Preservation Department – Item 2, LPC-23-02975

**112 2nd Avenue – East Village/Lower East Side Historic District  
Borough of Manhattan**

SUPPLEMENTAL PRESENTATION IN SUPPORT OF MCC APPLICATION

**Supplemental Statement  
in support of the  
Middle Collegiate Church  
Application for a Certificate of Appropriateness  
December 12, 2022**

DEMOLITION SEQUENCE

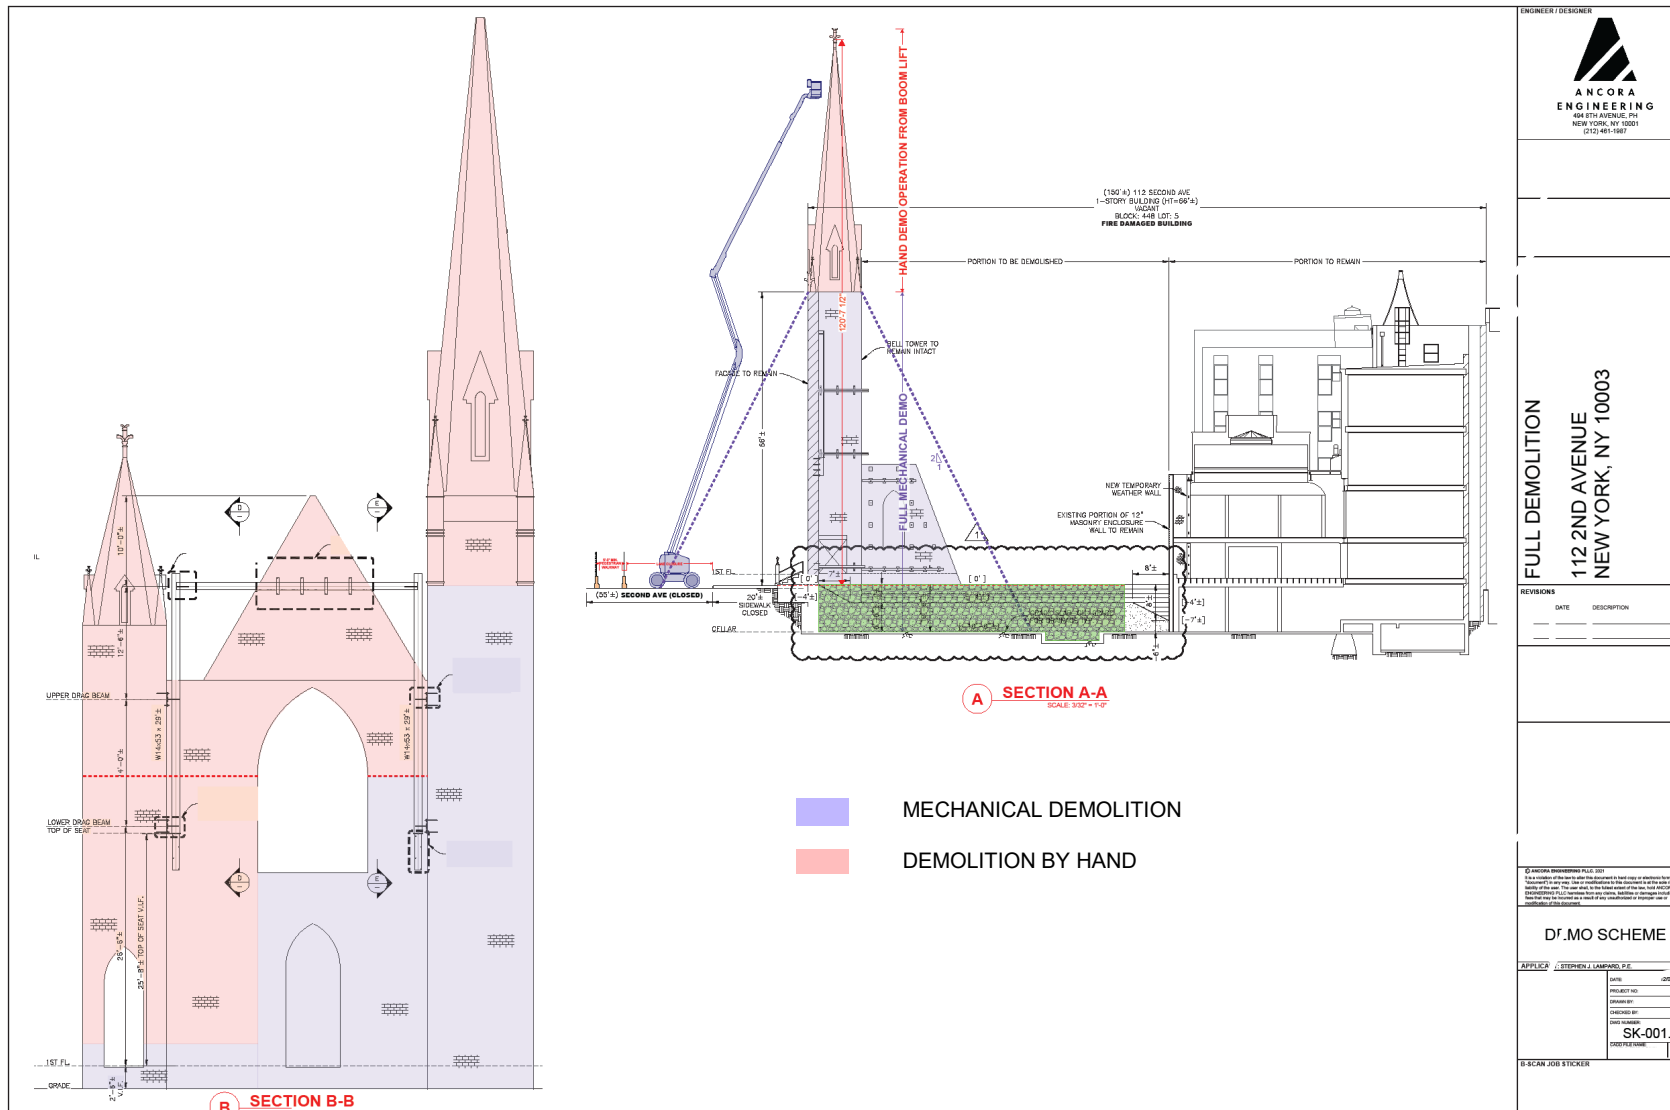
*“It is possible that demolishing the structure may be difficult and might not*

*be easier than maintaining it. This topic needs to be given more consideration by the Owner's team." P. 8*

*“3) a) Provide a detailed sequence of demolition. The height of 53' appears to be the top of the front wall, but the bell towers seem higher<sup>12</sup>. The heights and existing information must be further clarified.”*

See supplemental slides 17 and 18 for demolition sequence.

The demolition sequence would commence with the highest danger and remove that, then the next highest point based on what was observed, and then moving to the next segment. See supplemental slides R-17 and 18 for the demolition sequence
